SERVICE INFORMATION

M129.0

Date: 7/11/12

RE: Crane Merchandising Systems DN5800/3800-4 Door Seal Strip.

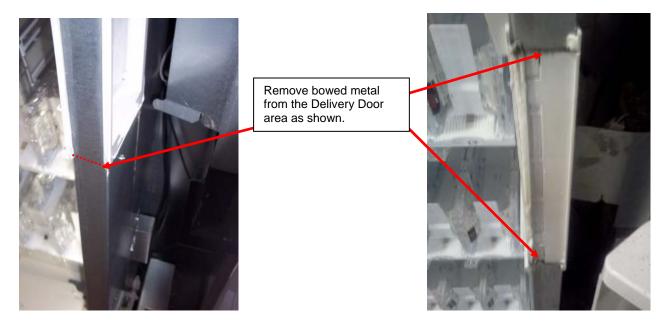
Inspect vender and confirm BevMax 4 does not have a Door Seal Strip and that the panel metal is bowed away from the Delivery Door area.

- 1. Unplug the vender from power supply.
- 2. Carefully remove the bowed metal from the Delivery Door area as shown. This can be done with a Dremel Tool, Hack Saw, or Tin Snips. Use caution as cut metal can be sharp.

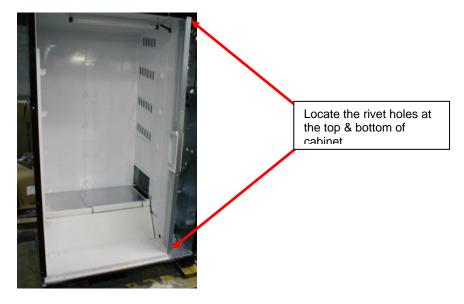
3. Locate the hole at the top and bottom of the Cabinet where the Door Seal Strip will attach and dill out existing pop rivets using #10 drill bit.

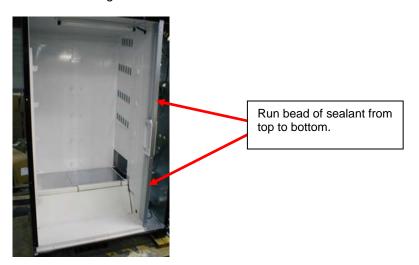
Once holes are ready, run a bead of sealant on the panel metal that the Door Seal Strip will lay against. This will provide an air seal to keep air from transferring form the hot & cold sides of vender.

5. Hold the Door Seal Strip in position and install 3/16" Pop Rivet in the Top Hole Location.
